Project	IEEE 802.16 Broadband Wireless Access Working Group < http://ieee802.org/16 >
Title	Codebook based beamforming in AAS zone
Date Submitted	2005-03-09
Source(s)	InSeok Hwang, Jaehee Cho, Seungj Maeng, is91.hwang@samsung.com JangHoon Yang, Hoon Huh, SangHoon Sung, Jaeho Jeon, Soonyoung Yoon Samsung Electronics Co. Ltd.
Re:	Recirculation of P802.16 REVe/D6
Abstract	Codebook based beamforming scheme is proposed for AAS operation..
Purpose	Adoption of suggested changes into P802.16e/D7
Notice	This document has been prepared to assist IEEE 802.16. It is offered as a basis for discussion and is not binding on the contributing individual(s) or organization(s). The material in this document is subject to change in form and content after further study. The contributor(s) reserve(s) the right to add, amend or withdraw material contained herein.
Release	The contributor grants a free, irrevocable license to the IEEE to incorporate material contained in this contribution, and any modifications thereof, in the creation of an IEEE Standards publication; to copyright in the IEEE's name any IEEE Standards publication even though it may include portions of this contribution; and at the IEEE's

Fig. xxx. AAS Zone with AAS Mid-amble (4 Tx. antenna case)

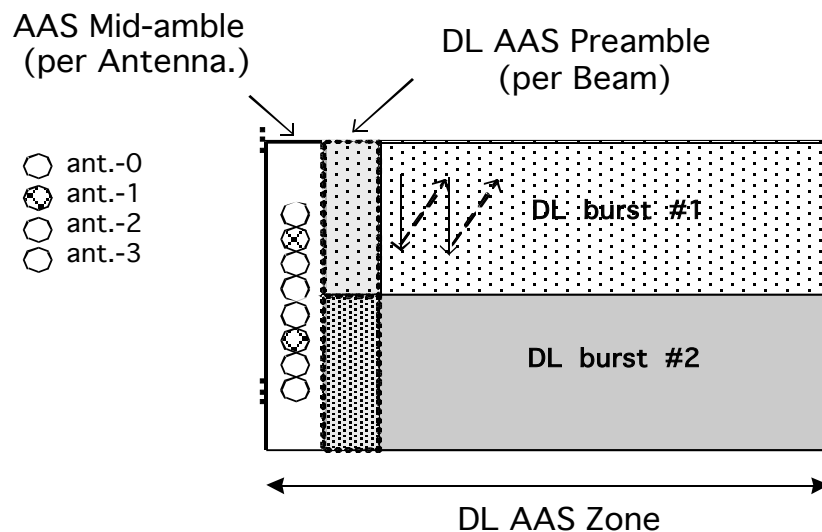
[Create “Codebook based beamforming in AAS zone” in Sec. 8.4.4.6.5]

To enable codebook based beamforming operation, BS may place an AAS Mid-amble at the first symbol in the first DL AAS zone. The definition of AAS Mid-amble is exactly same as MIMO Mid-amble defined in Sec. 8.4.8.5. The presence of AAS Mid-amble is indicated in AAS_DL_IE(). The BS can initiate the codebook based beamforming by assigning additional CQICH channel for SS to report predefined beam index. The set of beam forming vector is the same as the ones defined in Sec. 8.4.5.4.11. Only the codebook for single stream precoding in MIMO mode is used for codebook based beamforming in AAS zone. The number of Tx. antennas is known during the subscriber basic capability (SBC) negotiation process.
